# PACKARD MOTOR CAR COMPANY

January 15, 1929.

Subject: IGNITION TIMING.

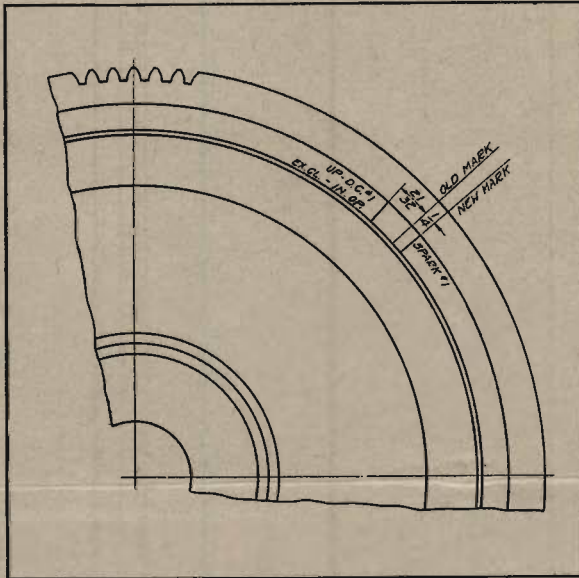
A change has been made in the automatic advance curve of the ignition distributor on all current model cars, requiring a change of the spark timing mark on the fly wheel.

The old distributor was indicated by type #10858 stamped on the plate on the side of the housing, and with this distributor the spark timing mark should be  $21/32$ " to the right of the upper dead center line on the fly wheel as viewed through the starter Motor opening. The type number of the new distributor is 10868-A, and with this unit the timing mark is  $29/32$ " to the right of the dead center line.

Only the new distributor will be supplied in the future, so that if one of the new units is used to replace the older design a new timing line should be permanently marked on the fly wheel as shown in the illustration, using a pair of dividers so that an accurate location can be obtained.
